NUCLEAR REGULATORY COMMISSION

Title: Advisor Committee on Reactor Safeguards
Subcommittee on ESBWR

Date: Friday, September 24, 2010

ESBWR Design Certification
Chapter 7 I&C

DCD Rev. 8 – Figure 7.1-1

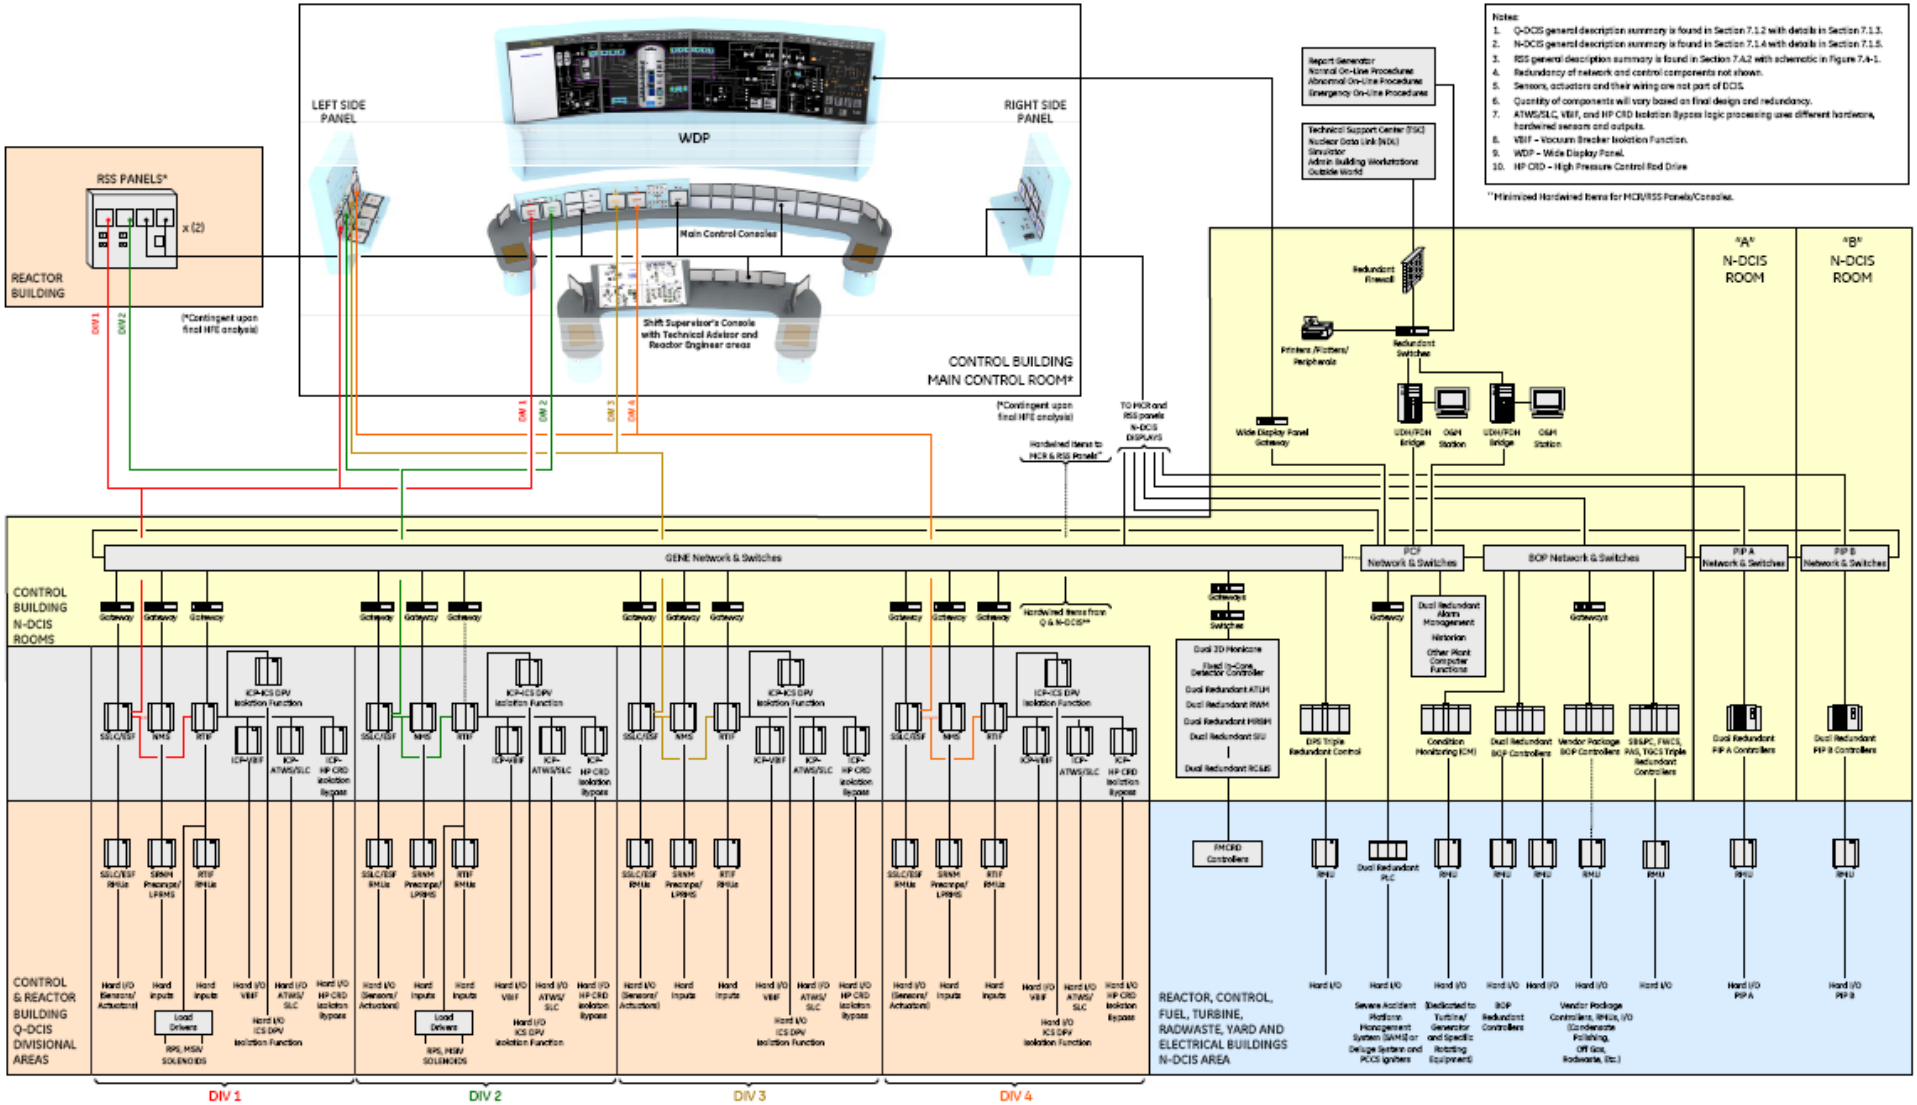
MR. POPPEL: This is a good diagram to occasionally refer back to, because you can get lost in exactly where we are in these systems. But overall, on the left side, you can see the four divisions. You can, if you have your glasses on, can see the three platforms in the divisions, the platforms being roughly what you guys would call the reactor trip system, and another one what you would call roughly the ECCS, which is SOC ESF, and the third one is the independent control platforms. And, in general, the whole plant is radial. In other words, the signals that things need, safety and non-safety, come to the processor directly. They do not come through a network. So, we do not use in the safety or non-safety side the network, which I'll put in quotes, to do data transfer. Essentially, our networks are

MEMBER BROWN: Question. You said the sensors enter from the bottom. Right?

MEMBER BROWN: You have separate RMUs for output, or are you using the same RMU to process plant data, that then goes to the RTIF, then it goes back down to the RMU and gets fed out to the scram breaker?

MEMBER BROWN: That gave me some difficulty the first time I went through this trying to figure out how anything from 3 and 4 got over to 1. That's why I asked, since you, obviously, knew what you were talking about.

MR. POPPEL: There are -- well, the right answer to that is it's a simple broad block diagram.

Figure 7.2-11a
Reactor Trip and Isolation Function (RTIF) Simplified Functional Block Diagram

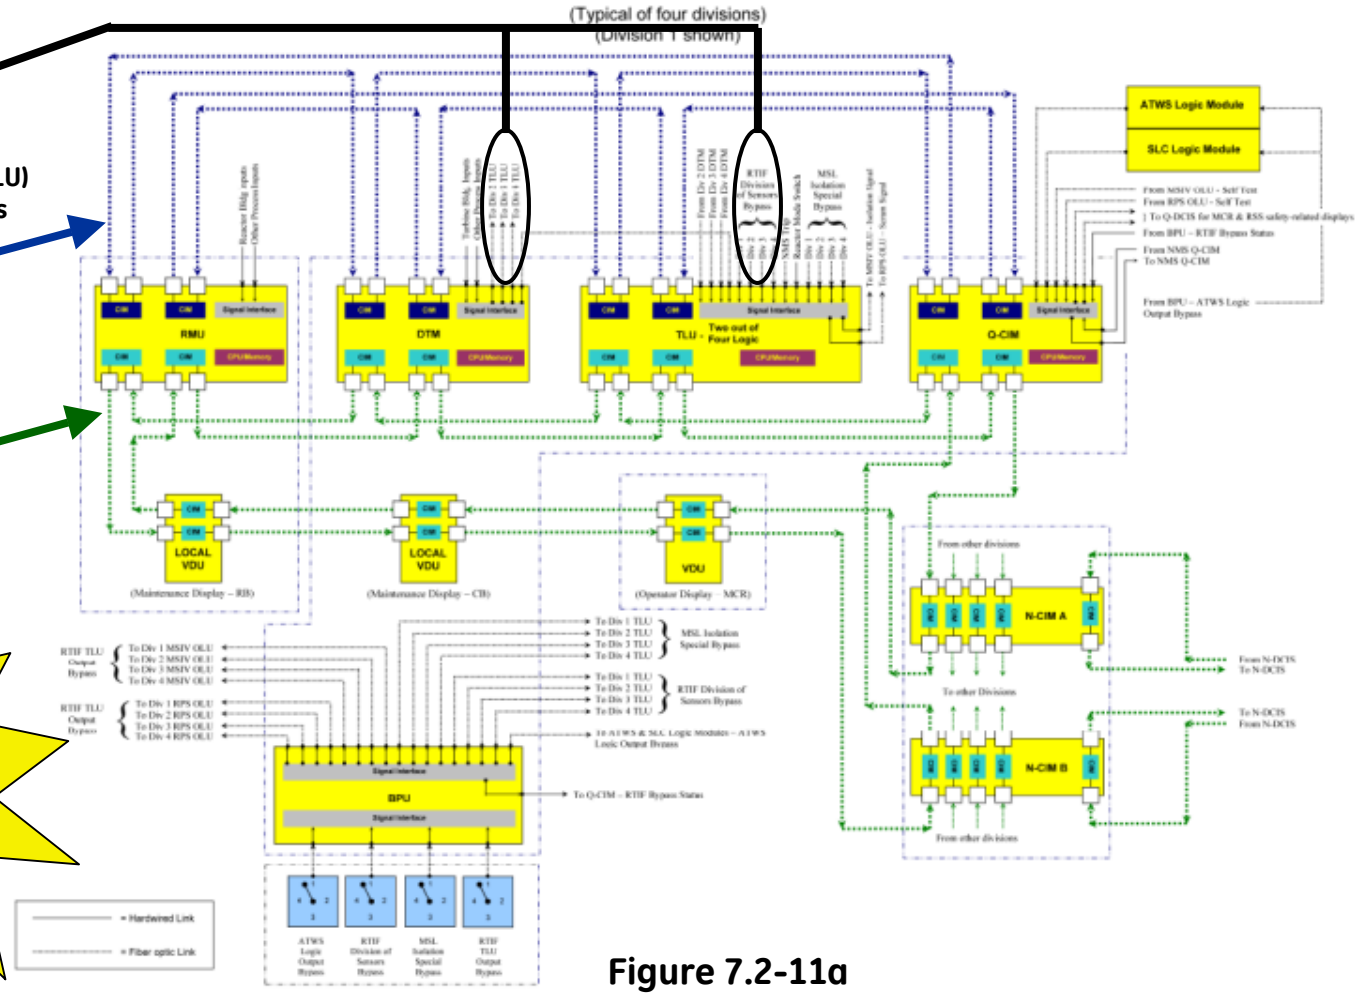
MEMBER BROWN: I'm looking at your figure here, which I saw in the Rev. 7 stuff, also. And I see the TLU. Then when I go look at Figure 7.2-1 in the DCD, it shows the output of the TLU going to an RPS output logic unit, which is not shown on here that I can see.

MEMBER BROWN: Well, I don't know. I haven't gone through your entire presentation. But, I mean, it's Figure 7.2-1, shows that, and it goes -- so, is the output logic unit -- why does it have to be a microprocessor? All it's doing is getting a division output unit singing a one or a zero off to -- or something, whatever you're sending. It's kind of maybe a load -- but it goes off to a load driver down where you have all the scram solenoids.

MR. BUTLER: That's in backup. It's Figure 7.2-11b from the DCD Rev. 6, and 7, and 8.

Figure 7.2-11a

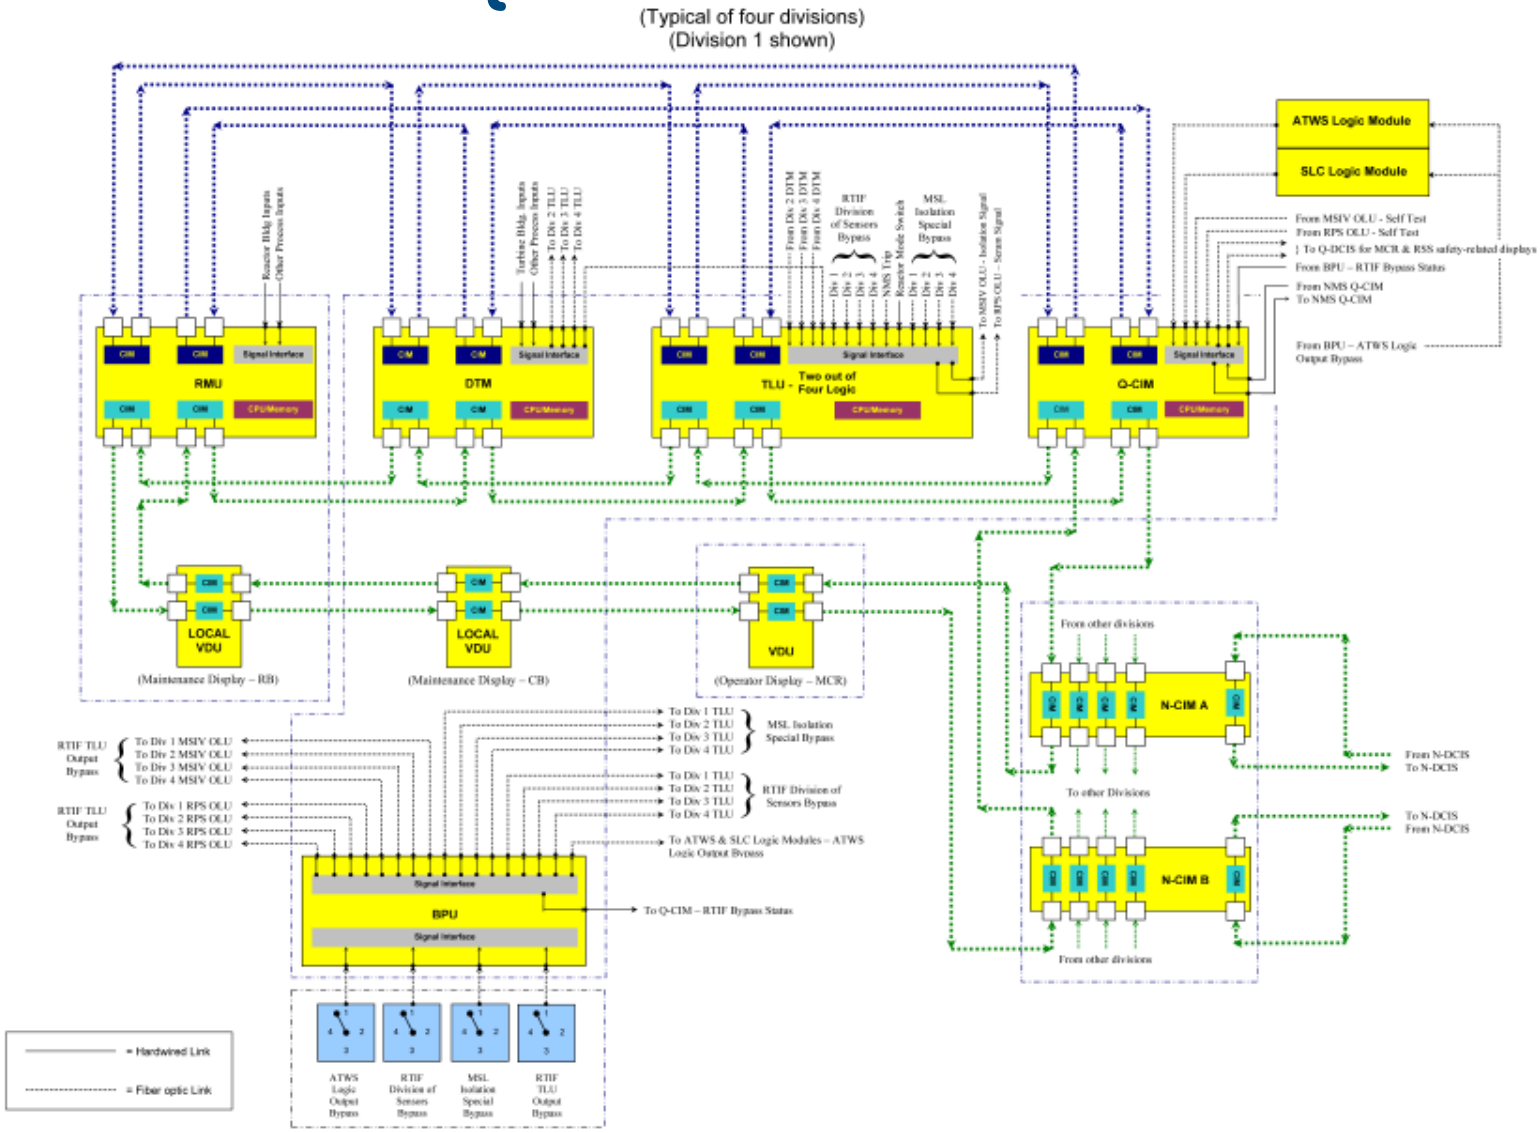
Add'l Design Detail – New Fig. (1/8)… Figure 7.2-11a From: RAI 7.1-139 – Question 3

Figure 7.2-11b

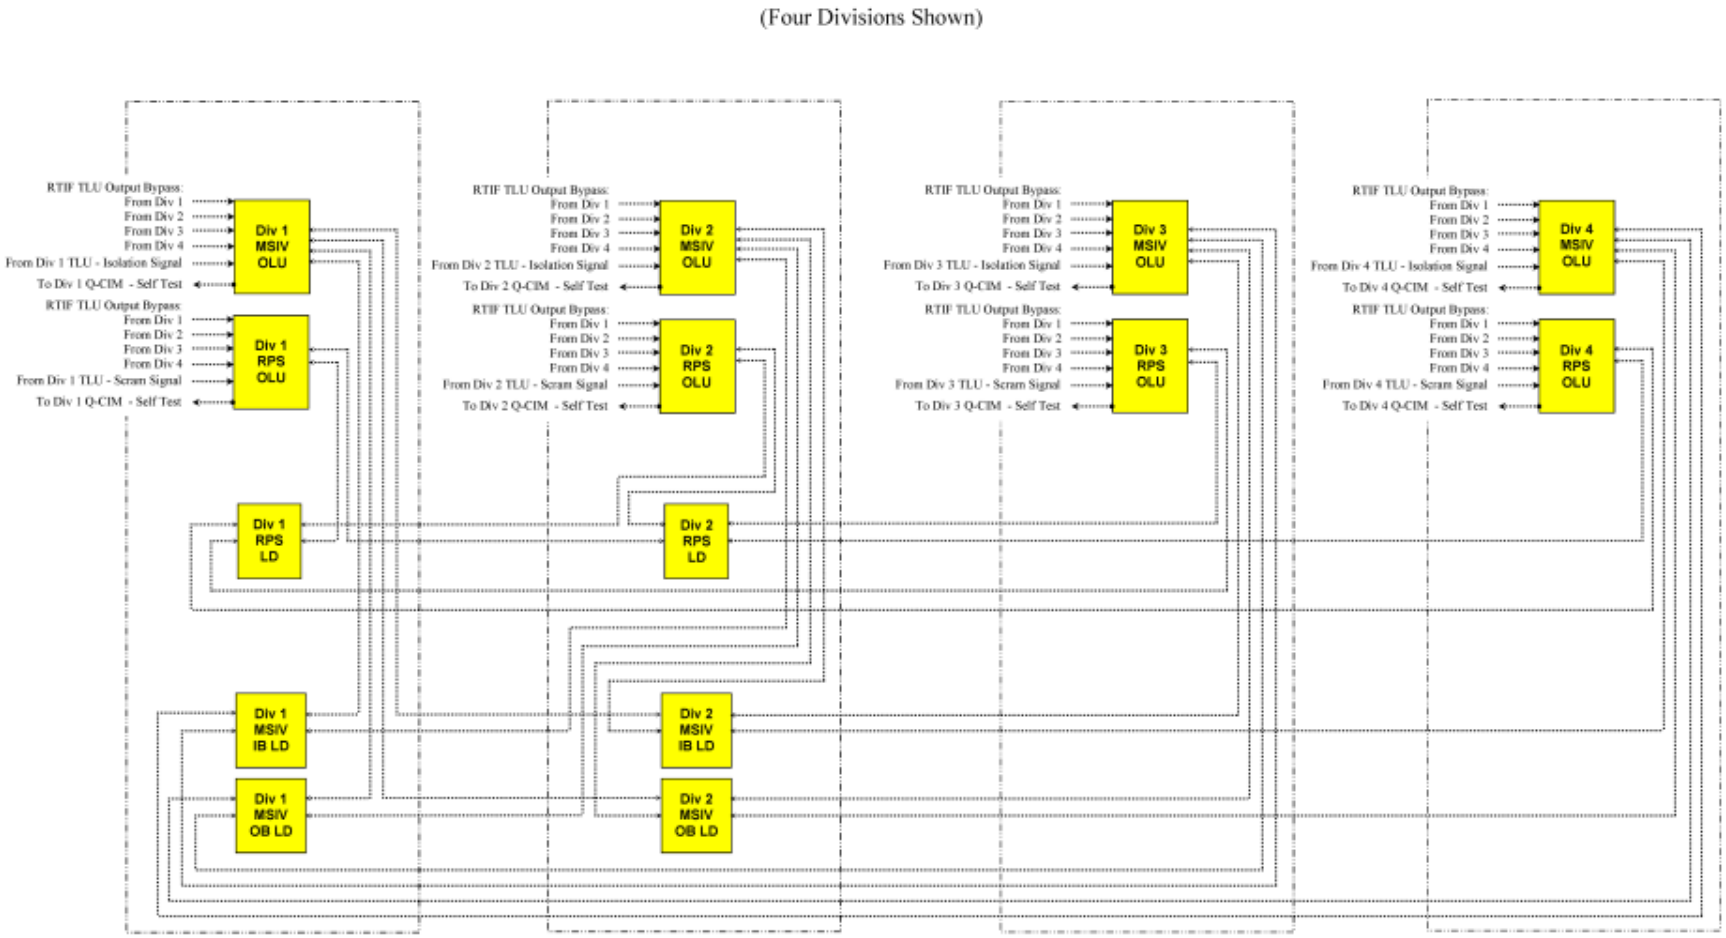
Add'l Design Detail – New Fig. (2/8)… Figure 7.2-11b From: RAI 7.1-139 – Question 3

Figure 7.2-12

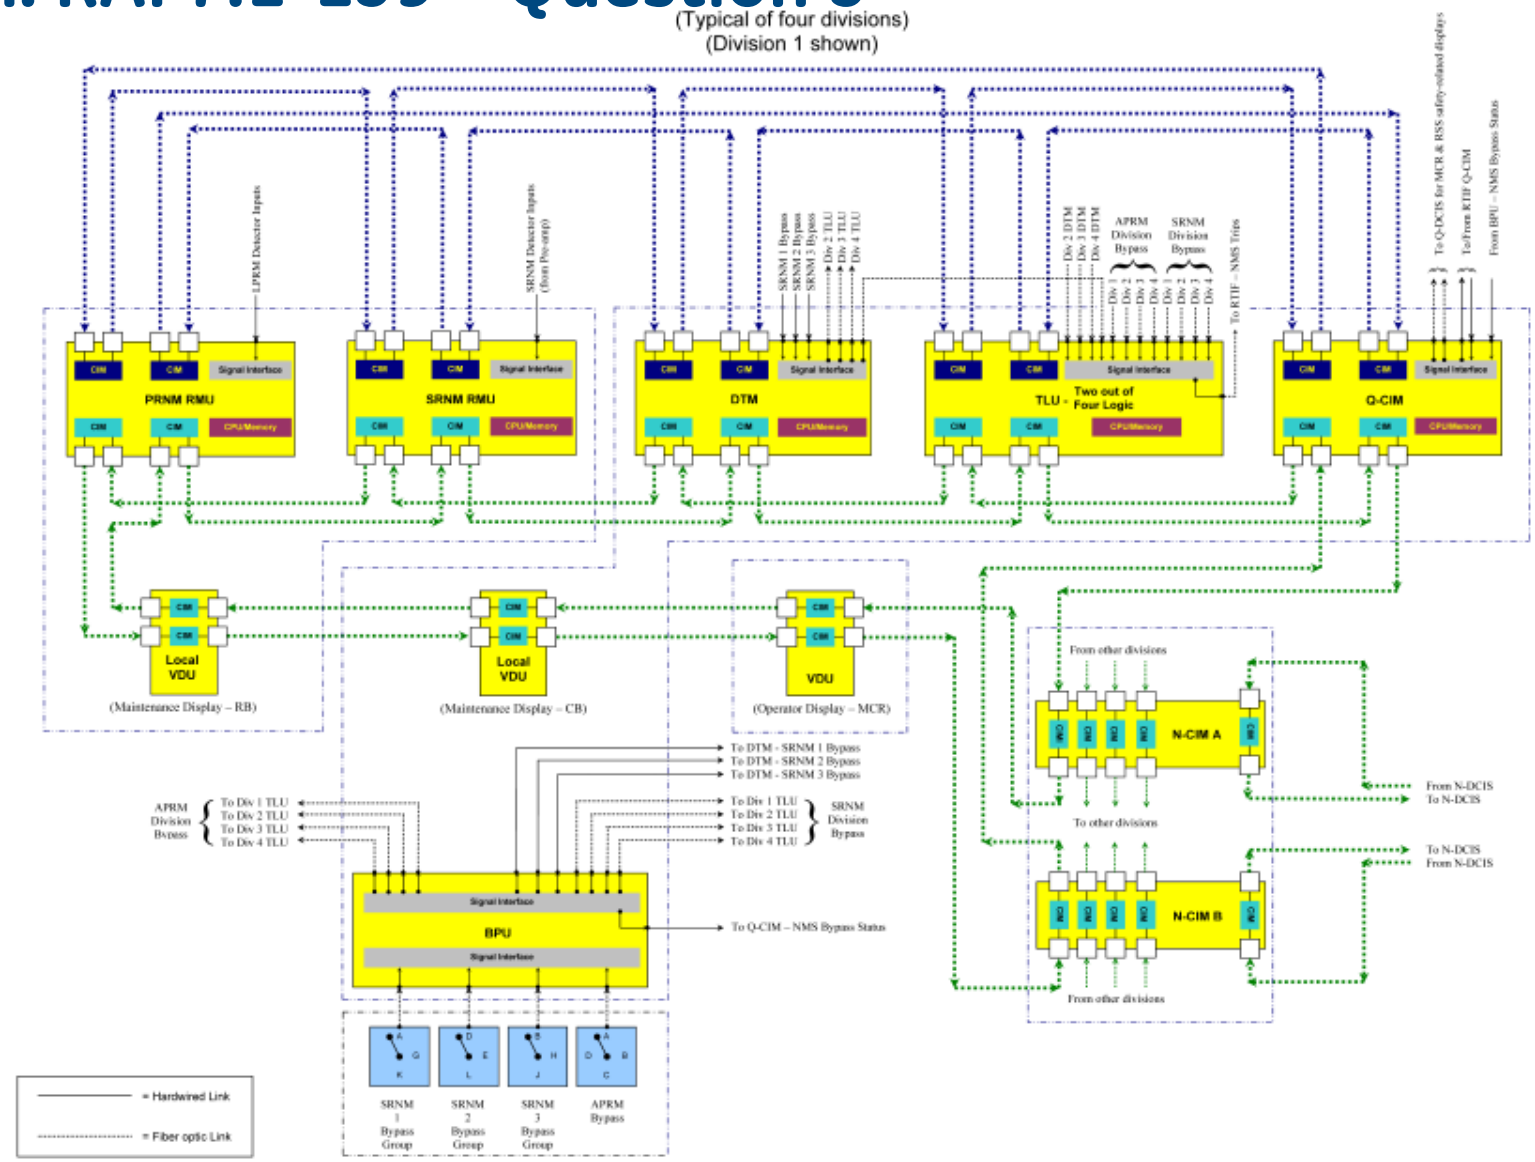
Add'l Design Detail – New Fig. (3/8)… Figure 7.2-12 From: RAI 7.1-139 – Question 3

Figure 7.3-6
SSLC/ESF Division 1 Layout

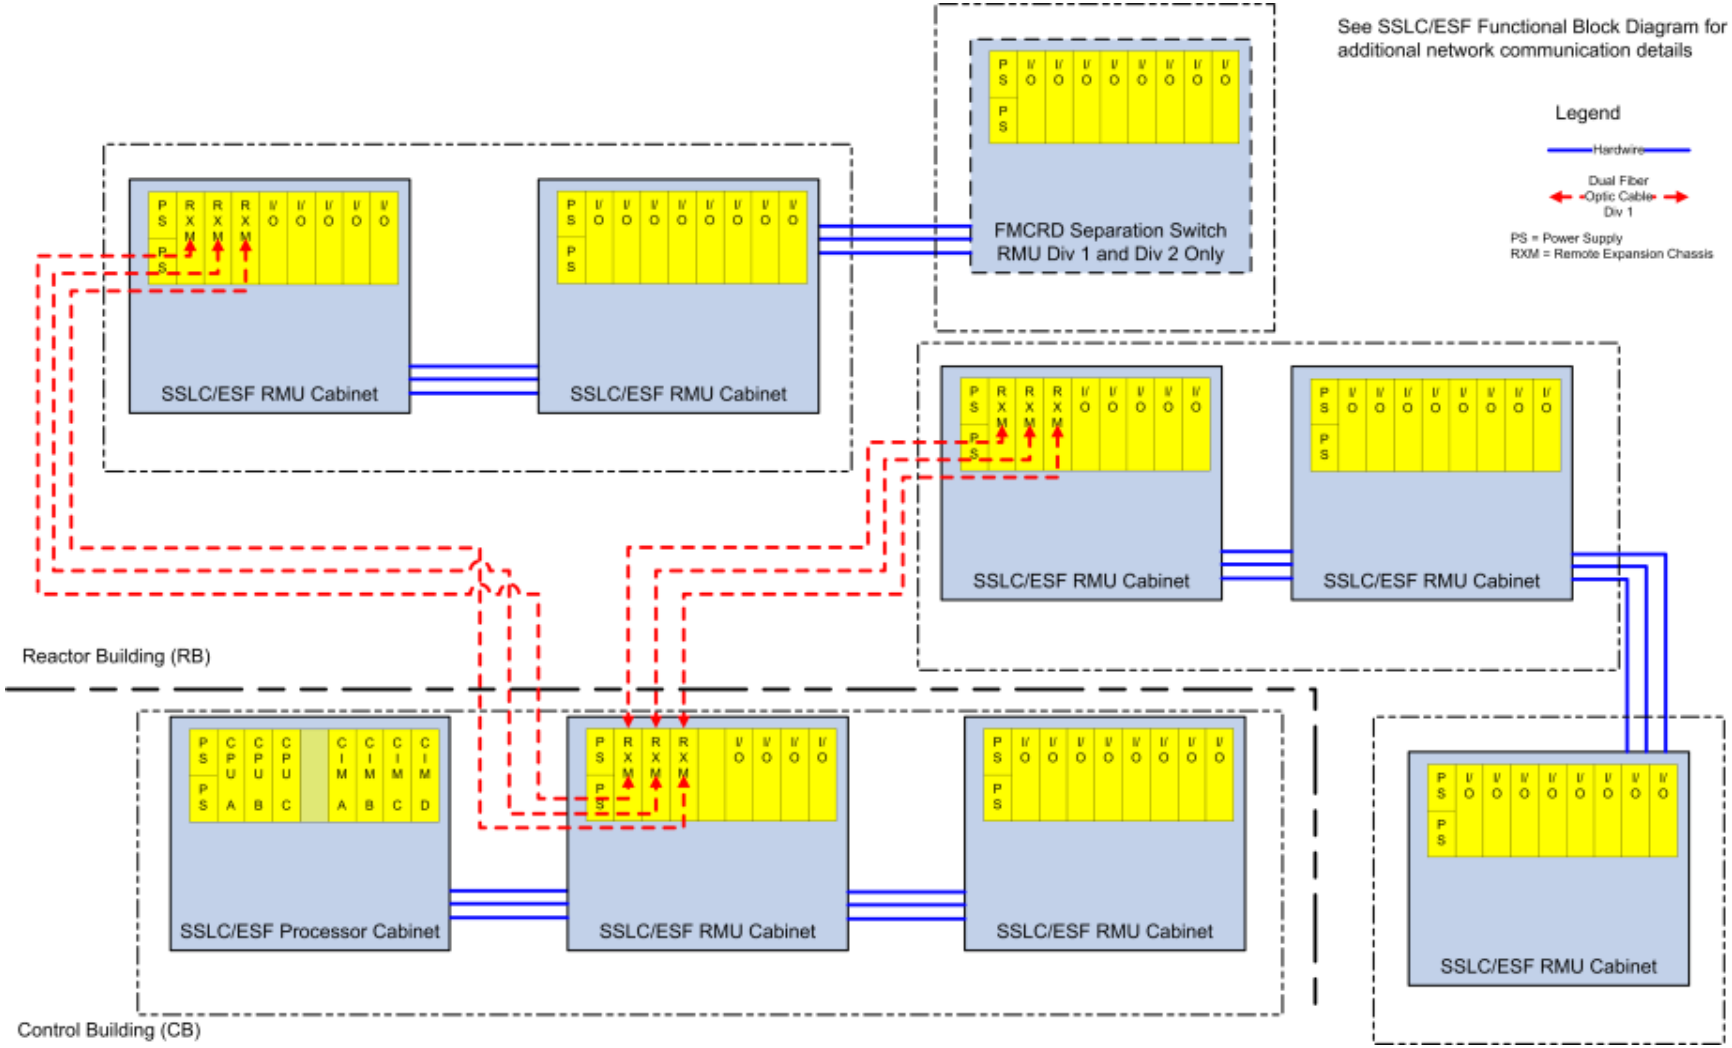
Add'l Design Detail – New Fig. (4/8)… Figure 7.3-6 From: RAI 7.1-139 – Question 3
